Project	<b>IEEE 802.16 Broadband Wireless Access Working Group</b> < <a href="http://ieee802.org/16">http://ieee802.org/16</a> >
Title	<b>BPSK Modulation for IEEE 802.16 WirelessMAN™ OFDM</b>
Date Submitted	<b>2004-01-13</b>
Source(s)	<b>Atul Salvekar</b> Voice: 408-545-9577, Fax: 408-545-9888, <a href="mailto:atul.a.salvekar@intel.com">mailto:atul.a.salvekar@intel.com</a> <b>Hassan Yaghoobi</b> Voice: 408-545-6162, Fax: 408-545-9898, <a href="mailto:hassan.yaghoobi@intel.com">mailto:hassan.yaghoobi@intel.com</a>  <b>Intel Corporation</b> <b>CHP3-105</b> <b>350 East Plumeria Dr.</b> <b>San Jose, CA 95134</b>
Re:	Supporting document for Letter Ballot #13
Abstract	In P802.16 REVd/D2 [1], both Single-Carrier and OFDMA PHY modes use BPSK as a robust type of modulation recommended for data and/or control channels. In particular, comments 206 and 429 from Working Group Letter Ballot #13 are referring to application of BPSK in SCa-PHY. Currently OFDM-PHY only supports robust modes of operations such as AAS and STC only on data channels and not on the control channels. To achieve true link budget enhancement expected from these optional modes of operation, it is proposed to make BPSK modul

**Change 6:**

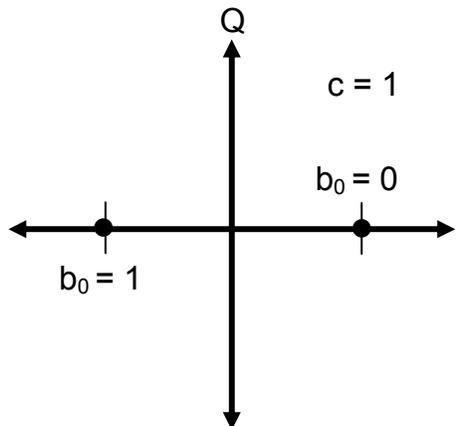
On page 411, Figure 197, add BPSK as follows to the set of constellation options:

Also change the caption on Figure 197 accordingly and as follows:

”BPSK, QPSK, 16-QAM and 64-QAM constellations”
